# Wollongong Local Planning Panel Assessment Report | 7 December 2021

<b>WLPP No.</b>	<b>Item No. 3</b>
<b>DA No.</b>	DA-2021/103
<b>Proposal</b>	Designated Development - Residential - demolition of dwelling house and construction of new dwelling house and swimming pool
<b>Property</b>	603 Lawrence Hargrave Drive Wombarra Lot 16 DP 5998
<b>Applicant</b>	Gyles Deacon
<b>Responsible Team</b>	Development Assessment and Certification - City Wide Team (KR)

## ADDENDUM REPORT

Scale @ A3 As indicated  
603 Lawrence Hargrave Drive, Wombarra, NSW  
Dwg Number **A-101** Issue 7  
Print Date & Time 2021-10-19 6:03:28 PM  
C:\Users\Ross Serrano\Desktop\MISC\WALTER BARDA DESIGN\Deacon\2021 05 26 - Deacon DA Amendment (bed added).nvt

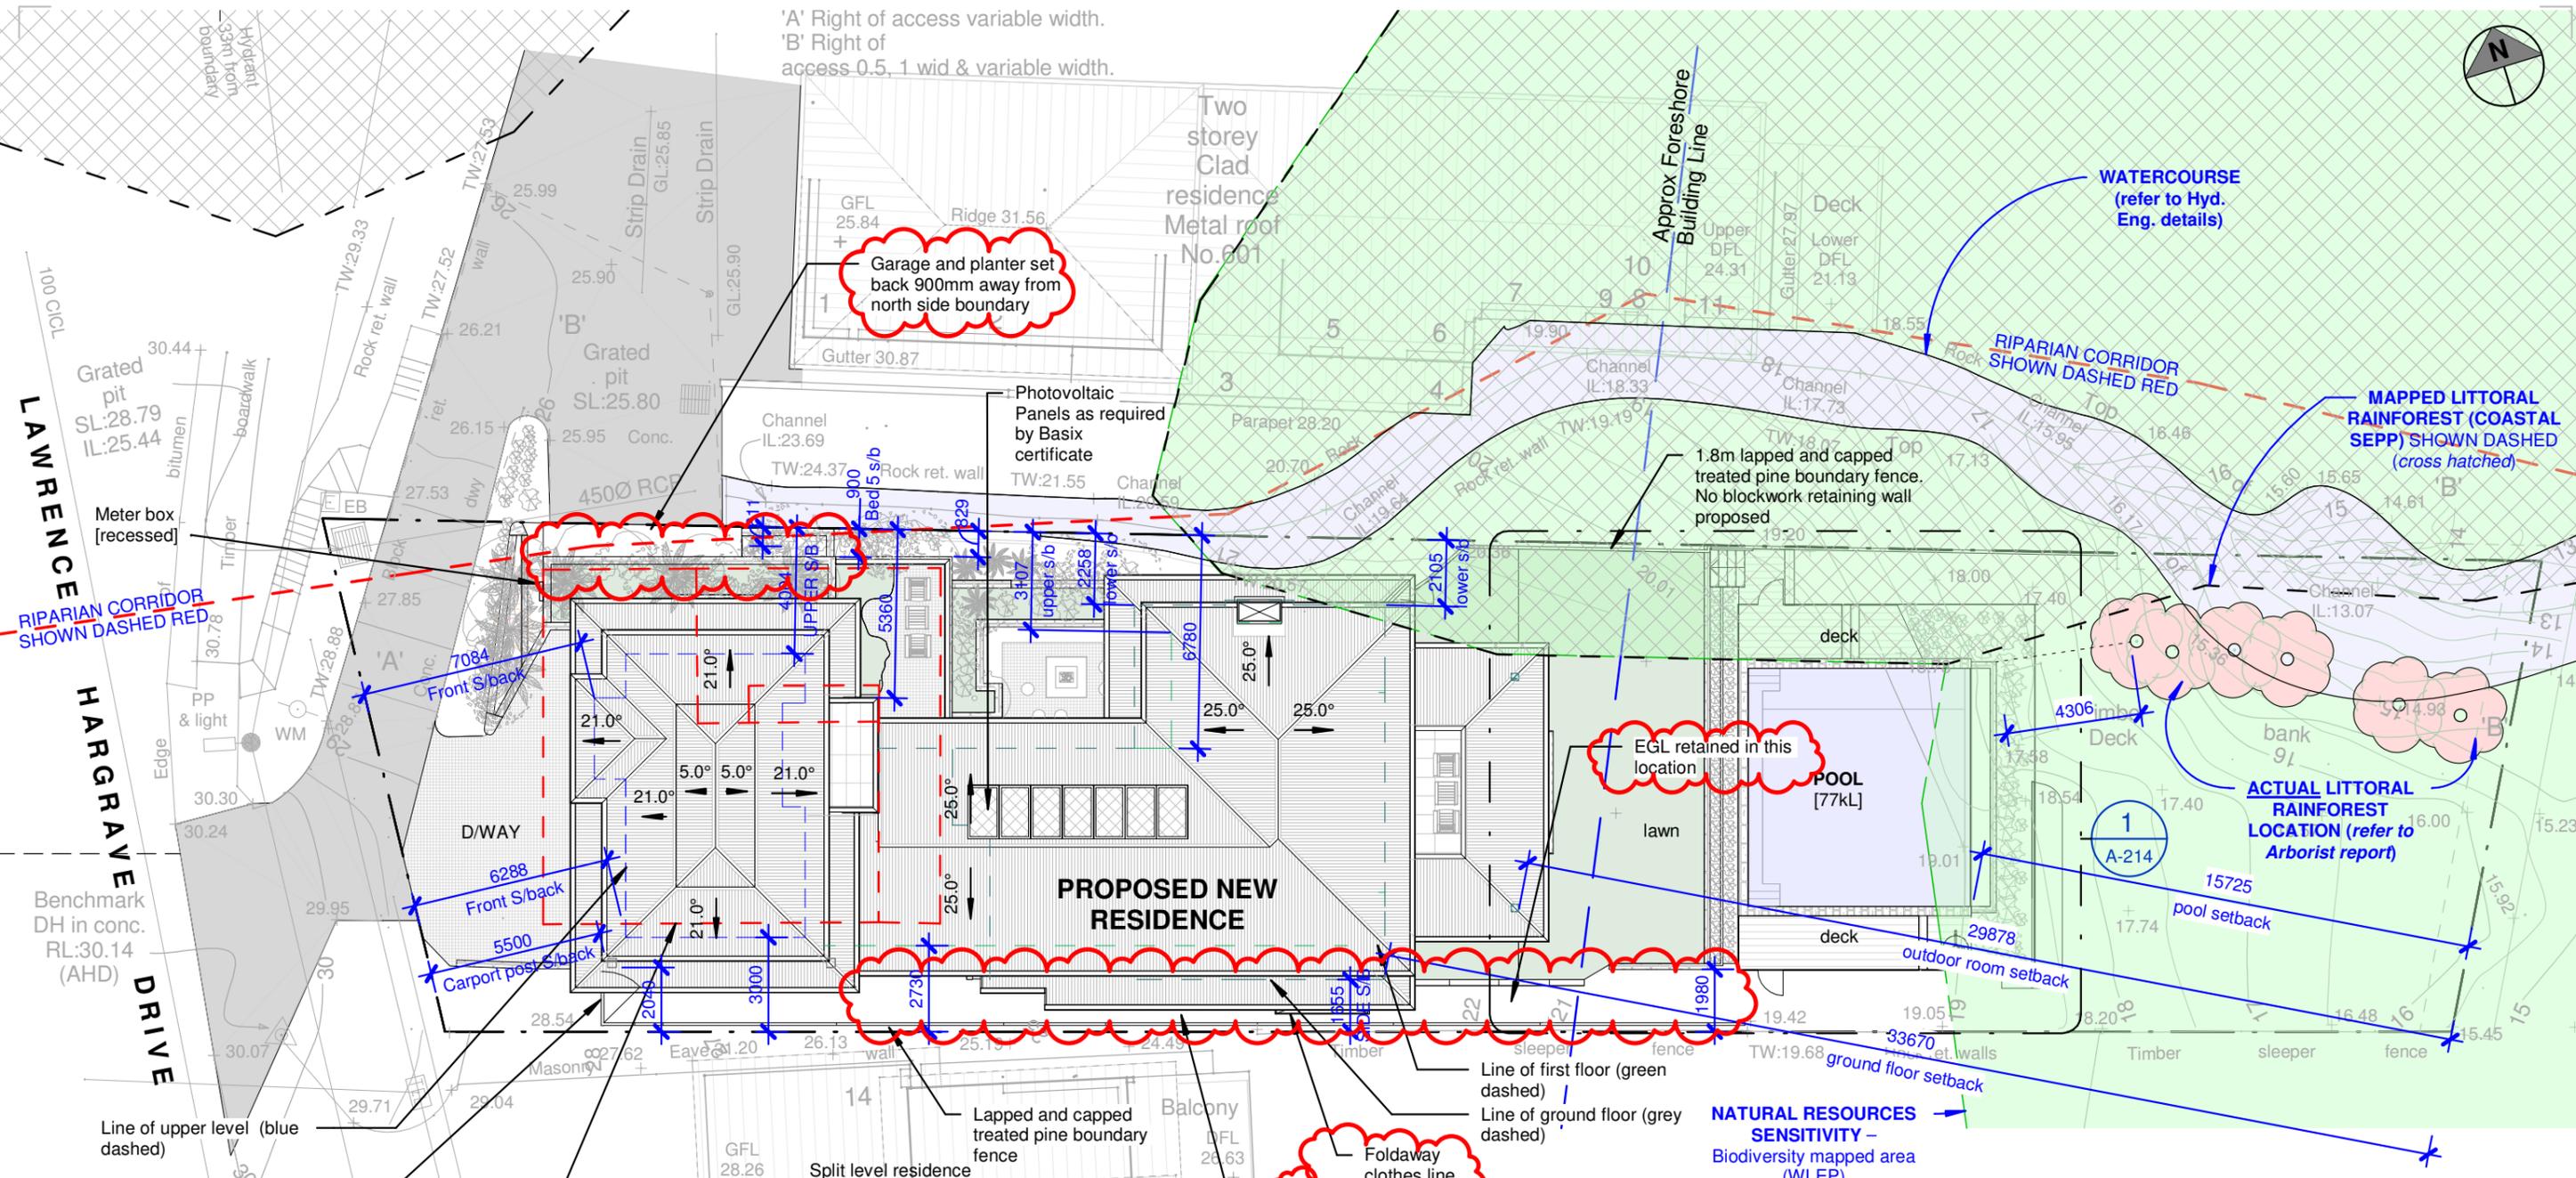
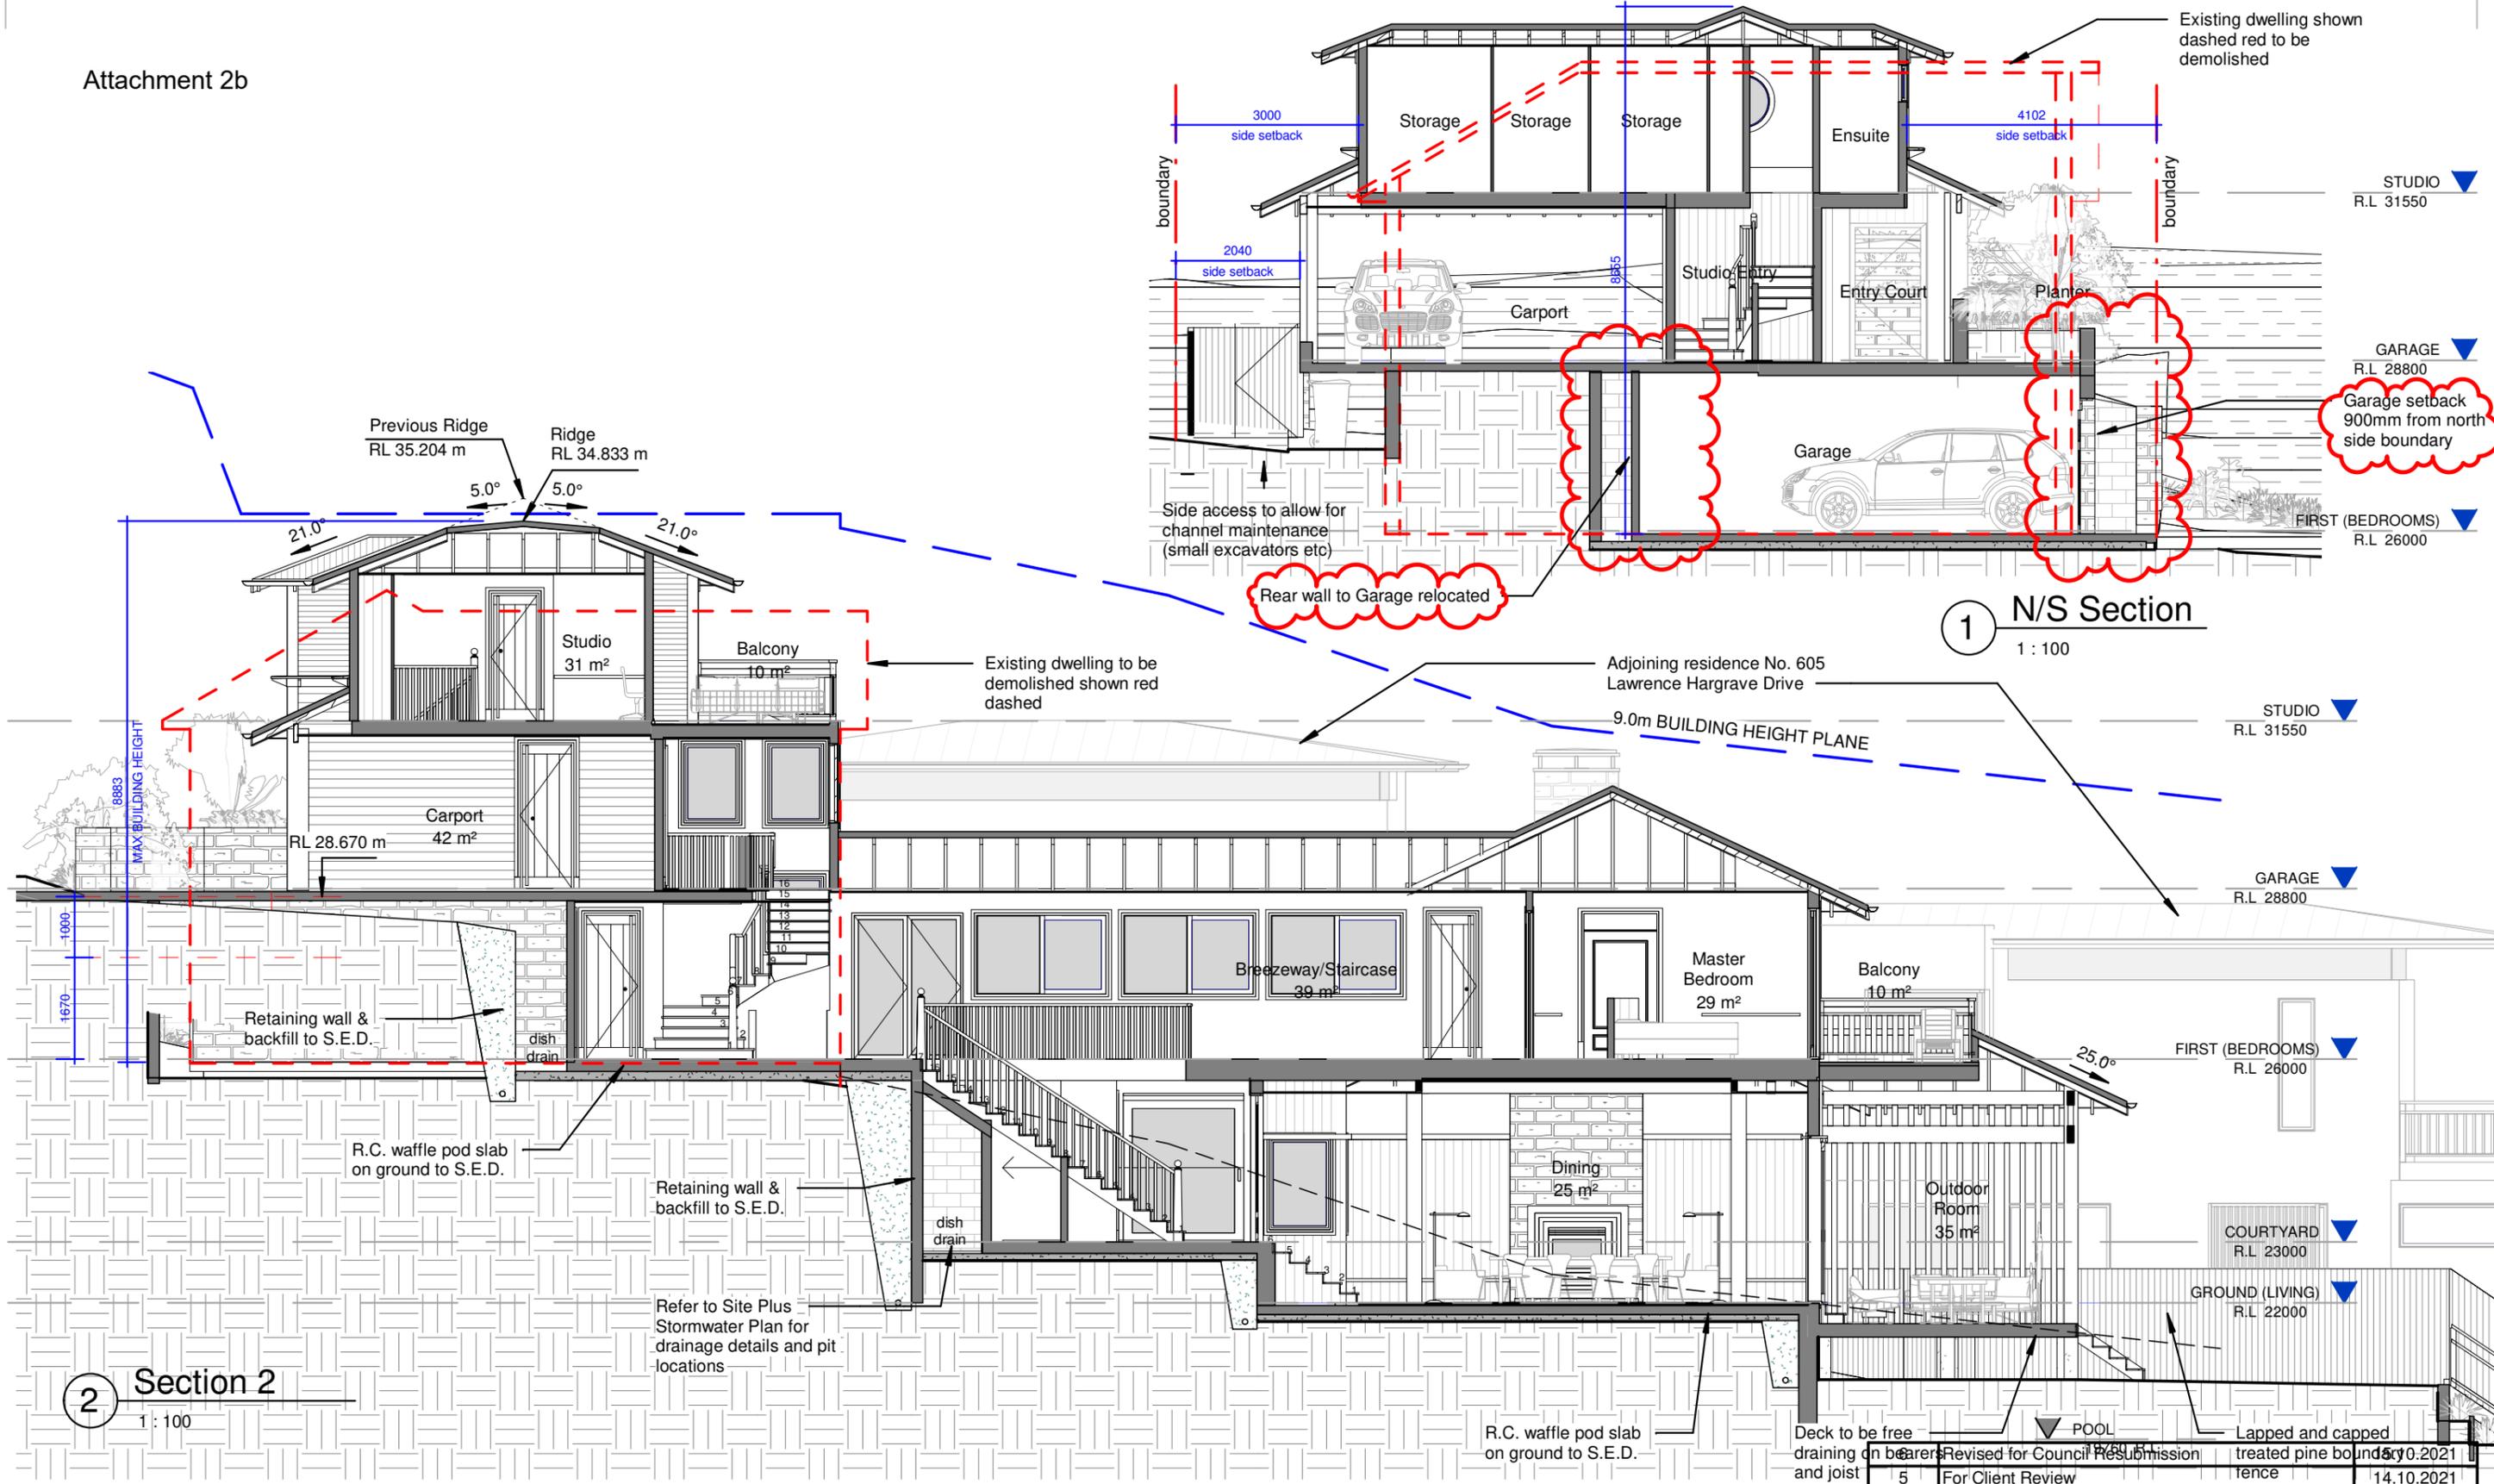
- *Setback of the garage from the northern side boundary to comply with the DCP controls.*
- *The applicant is to provide a swept path analysis demonstrating vehicular manoeuvring into and out of the proposed double garage can be achieved within the confines of the existing easement.*

- *Setback of the garage from the northern side boundary to comply with the DCP controls.*

- Lower garage setback increased to comply with minimum 900mm from northern side boundary to comply with the DCP controls.
- Swept path analysis submitted demonstrating vehicular manoeuvring into and out of the proposed double garage can be achieved within the confines of the existing easement.
- Side setback of master bedroom amended to comply with Council's DCP Chapter B1 Clause 4.3.
- Retaining wall on the southern side amended to comply with Council's DCP Chapter B1 clause 4.17. Geotechnical Report also amended due to amended plans.
- Arborist Report amended to include consideration of the littoral rainforest plantings on the neighbouring property to the north.
- Swimming pool and sewer pumps relocated to mitigate impacts on neighbours. Pump proposed to be enclosed in an acoustic enclosure to protect the amenity of the neighbours.

The lower garage setback to the northern boundary has been increased from nil to 900mm. The proposal now complies with Clause 4.3 of Chapter B1 WDCP 2009 which requires walls must be setback at least 900mm from any side or rear property boundary.
